SOUTHEAST SIGN CO.
ELECTRICAL SIGN AND LIGHTING SPECIALISTS
3375 NW 55th St. • Suite B • Ft. Lauderdale, FL 33309
954-332-2263

LOTIS
WELLINGTON, FL

FILE: LOT_WEL_MSP_R20_CHANGES
PATH: O:\Client Files\Lotis\Design\MSP\

C.1 Newly Proposed Sign Type C Locations
3/8" = 1'-0"

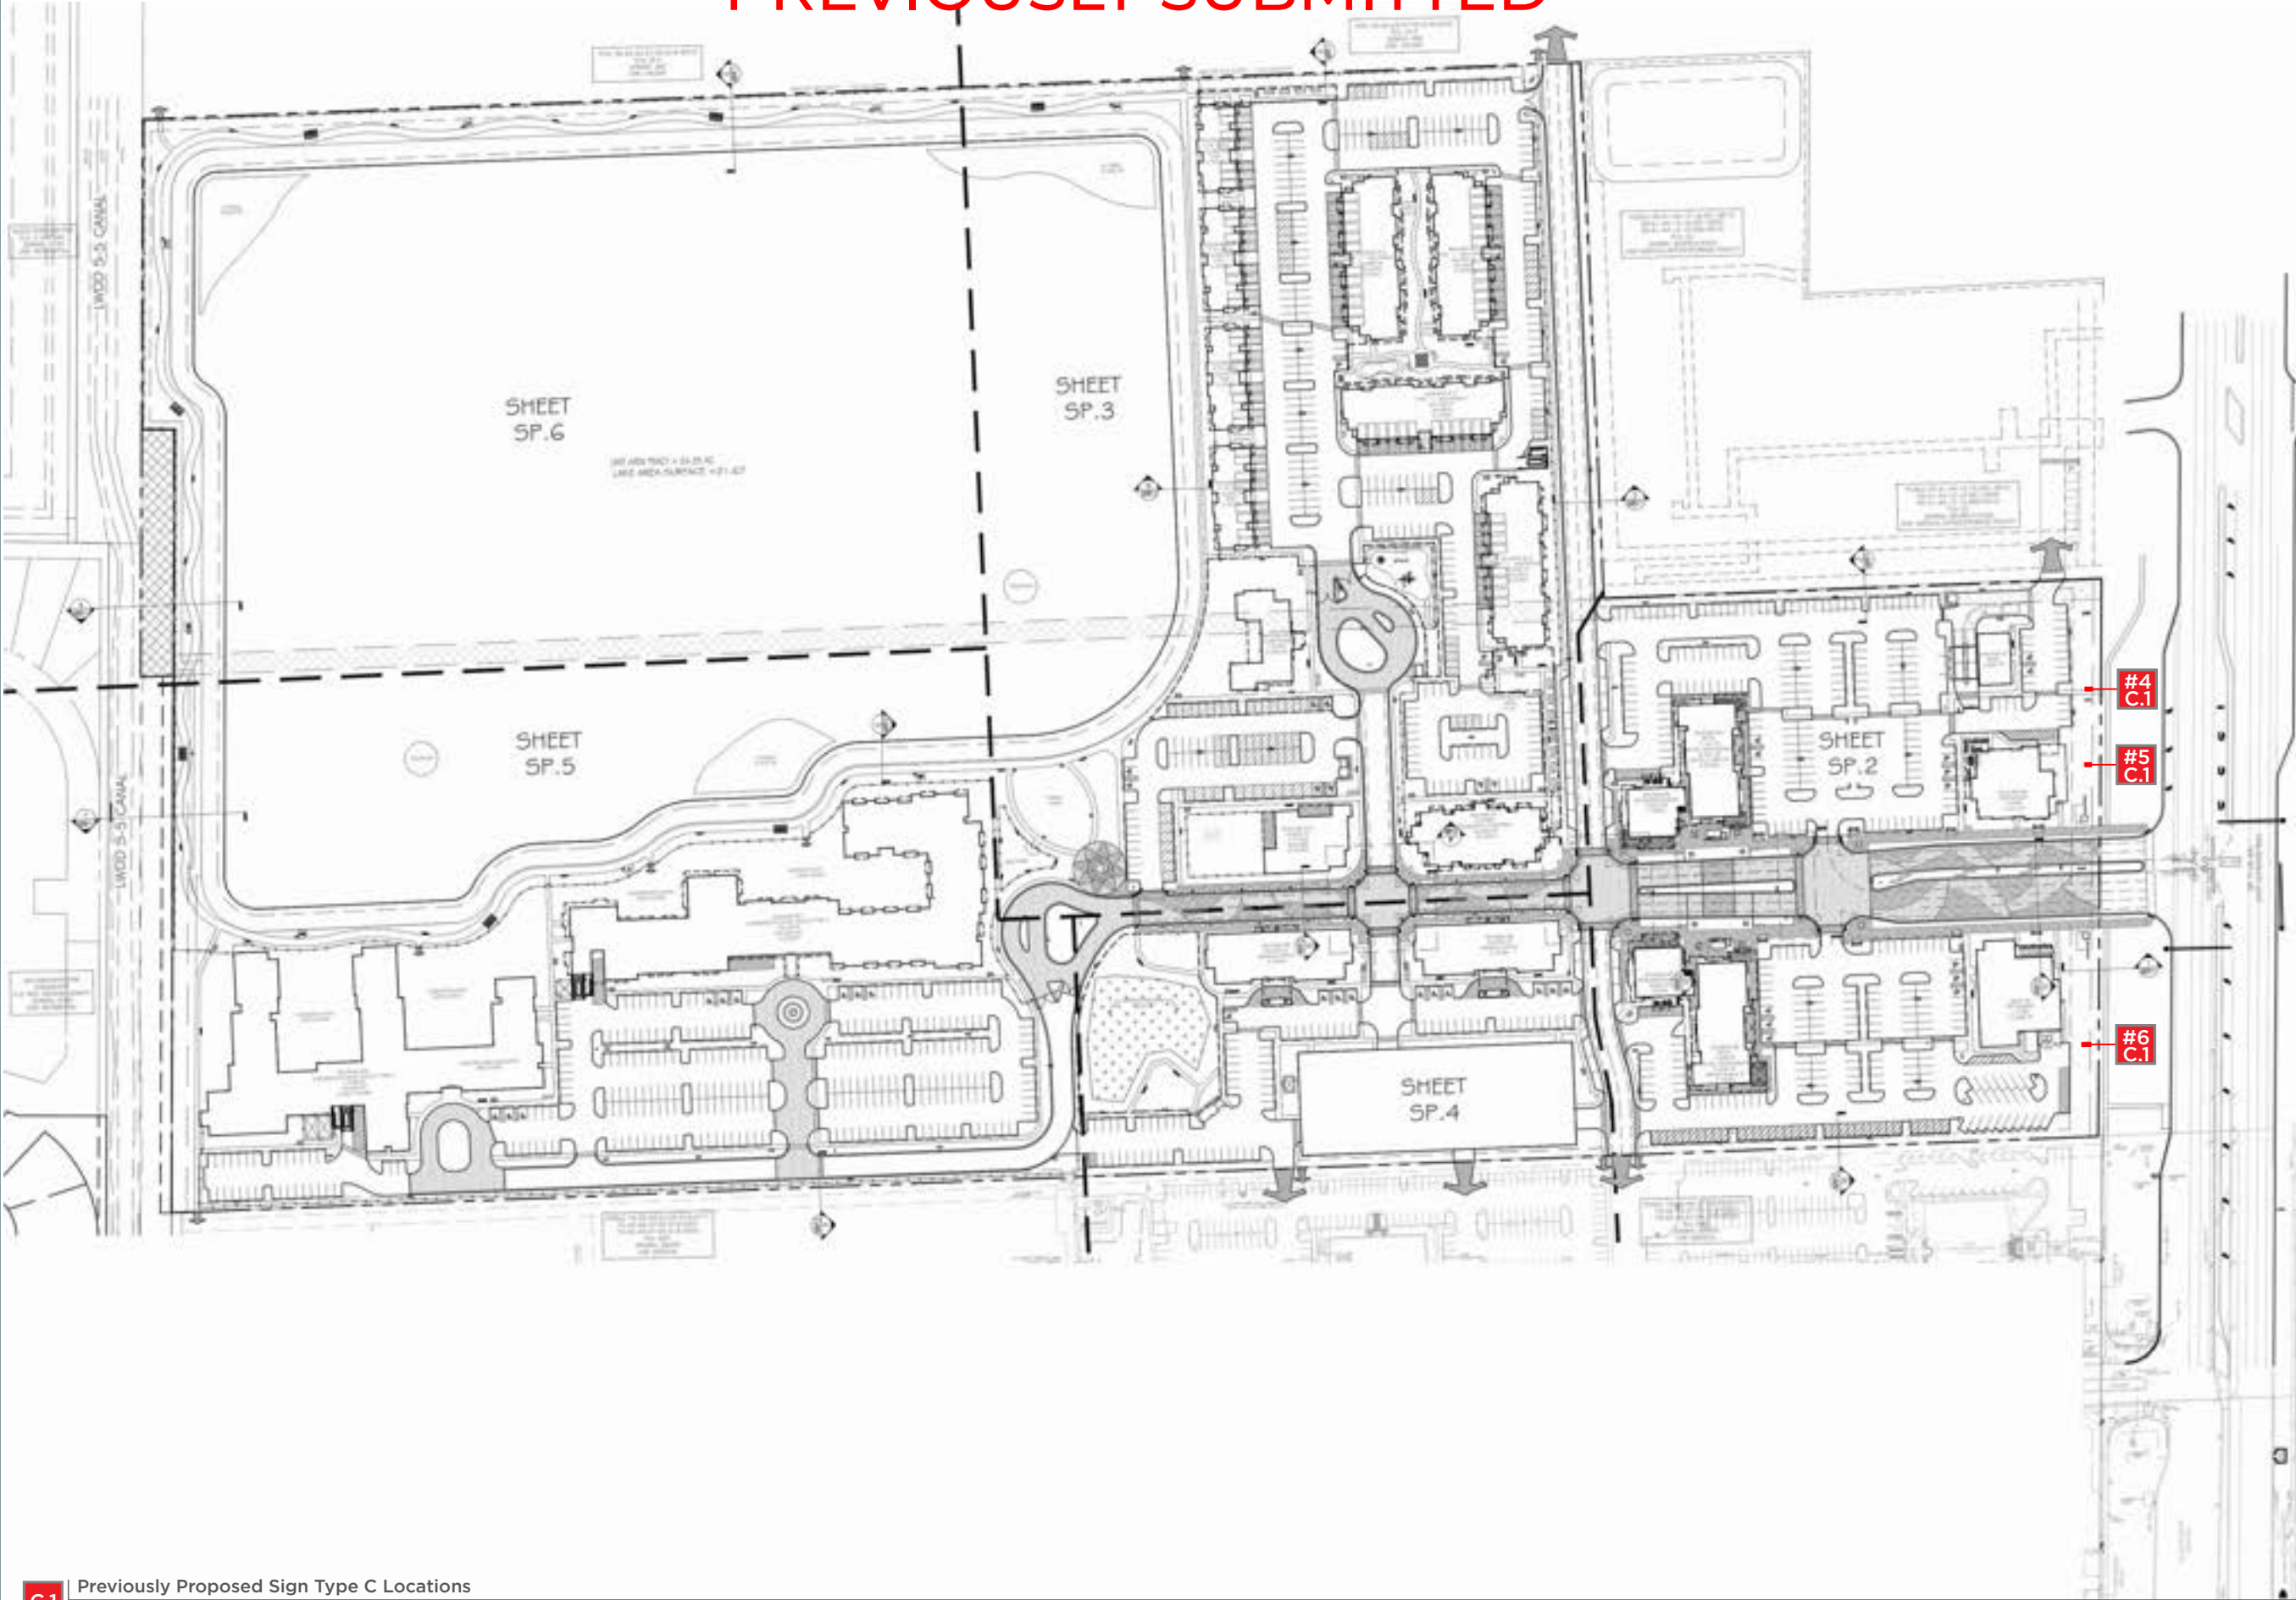
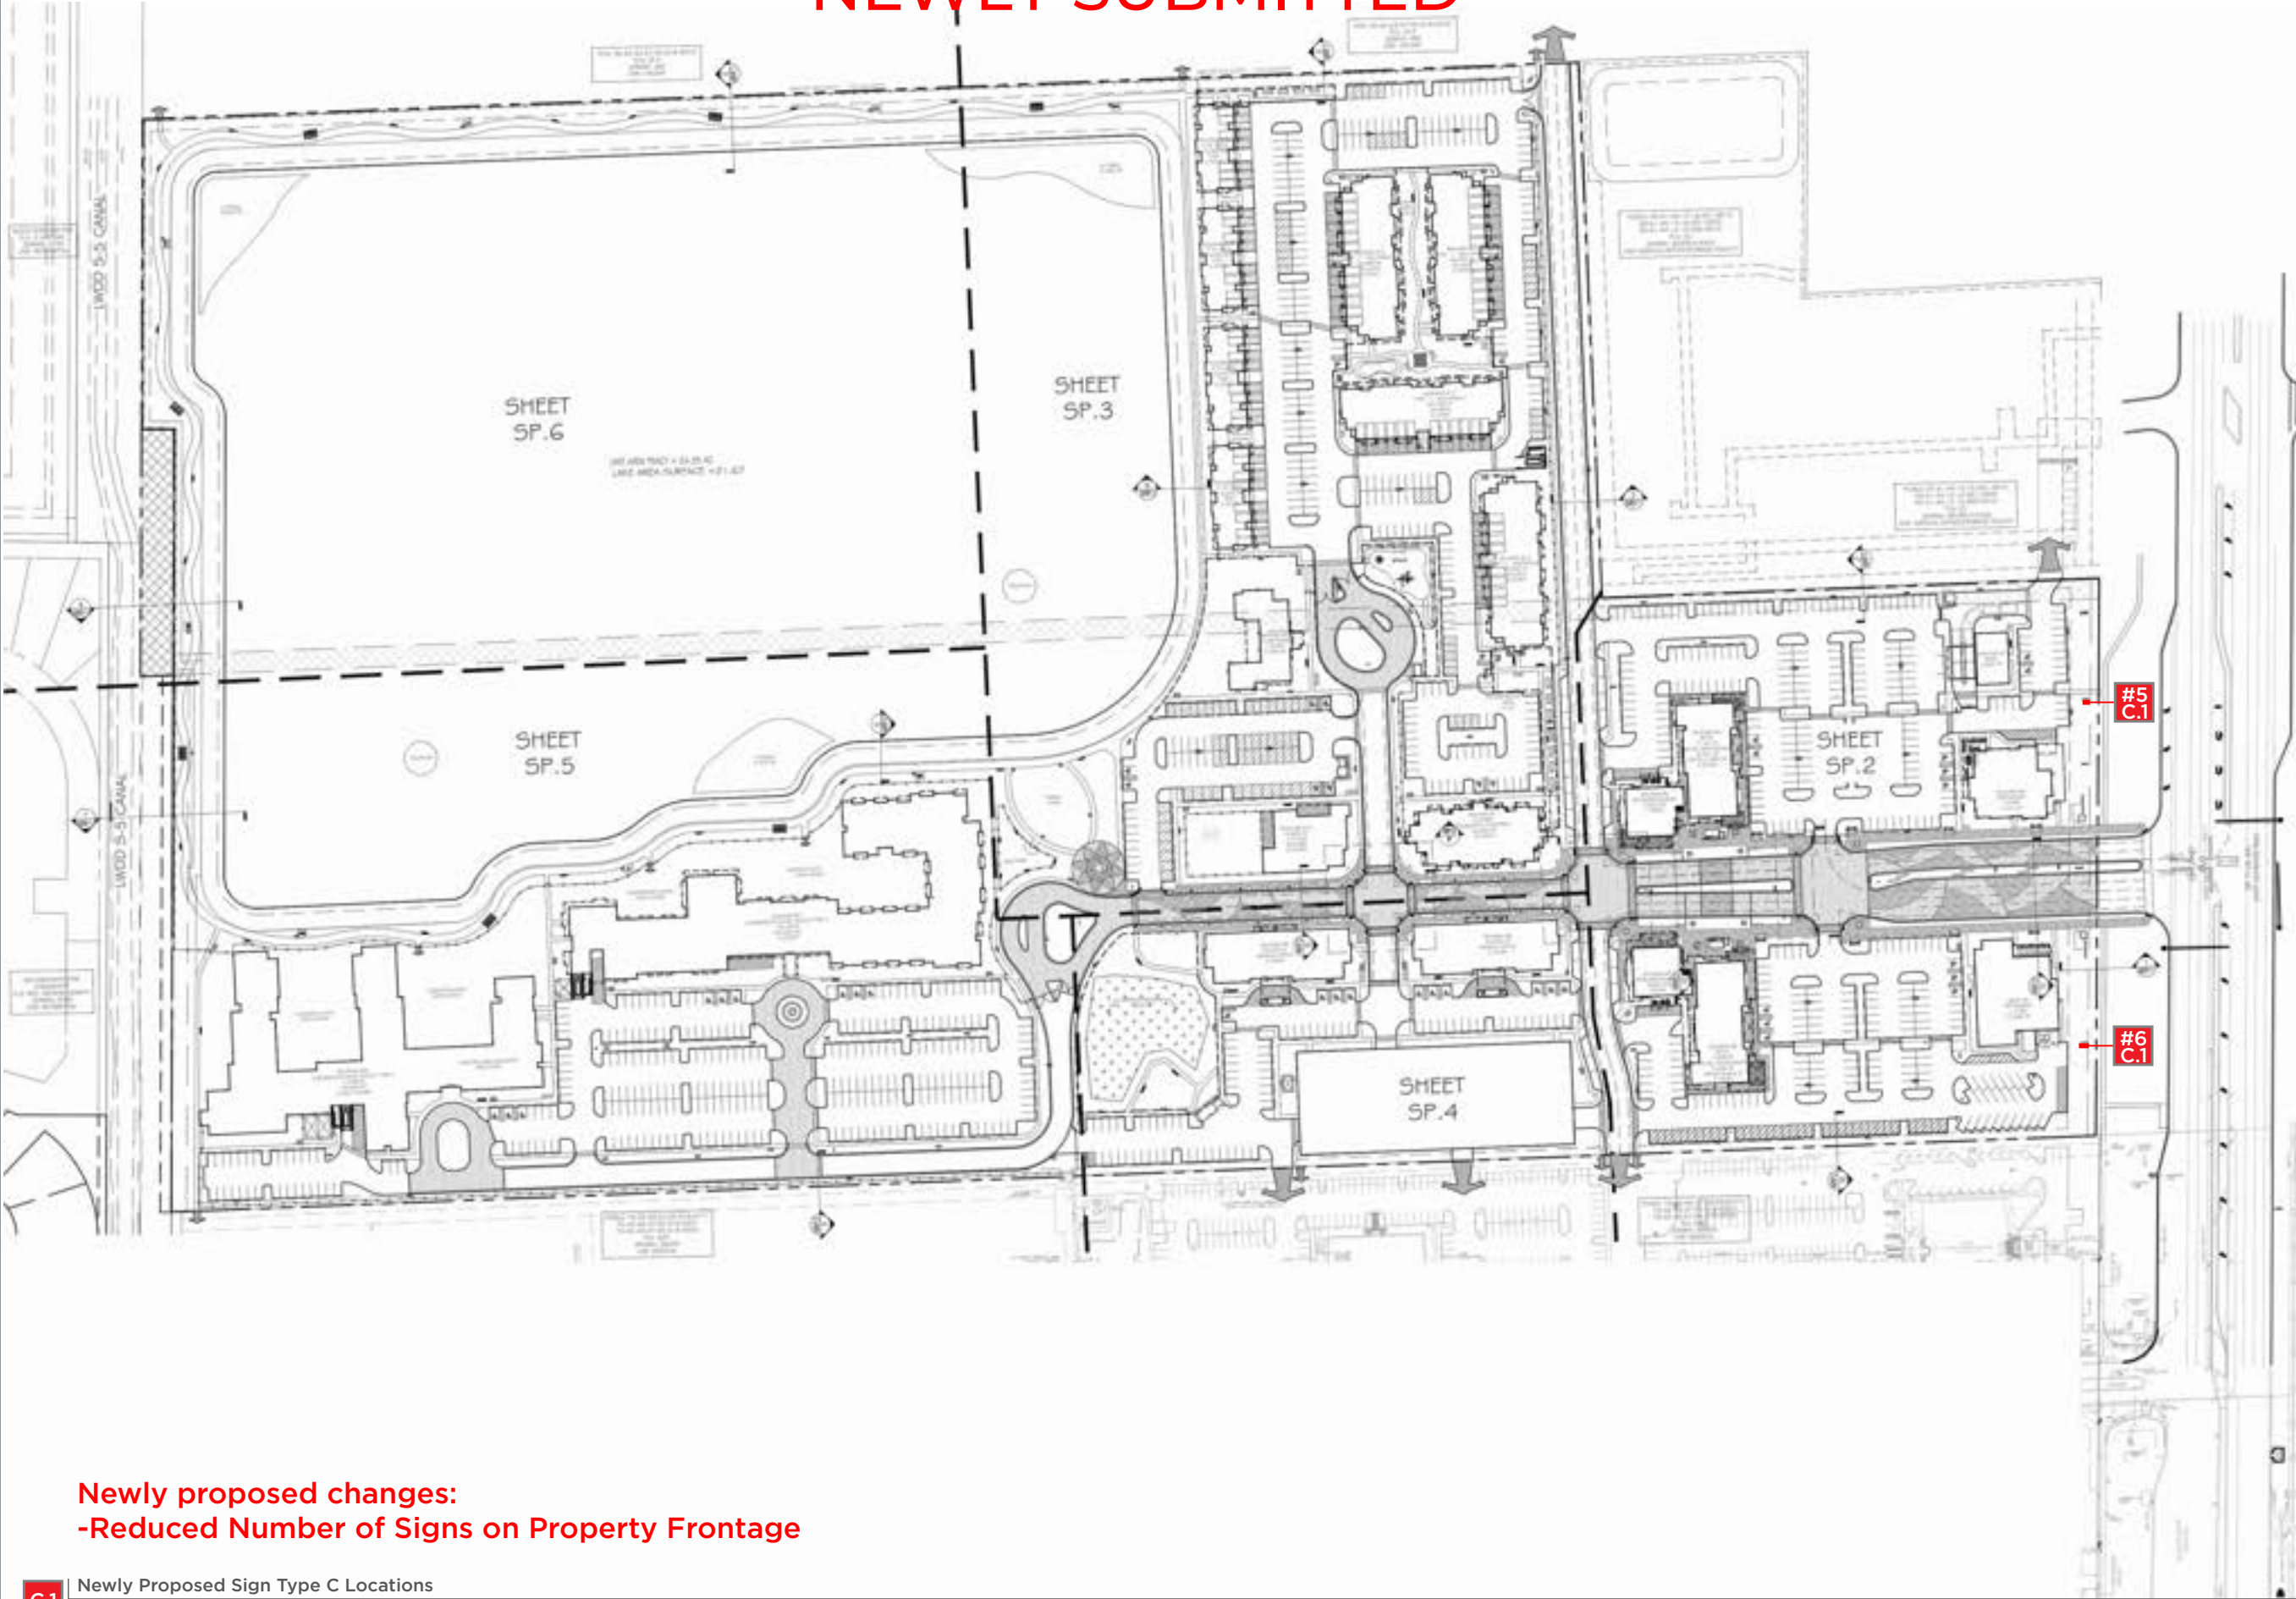
Newly proposed changes:
-Reduced Number of Signs on Property Frontage
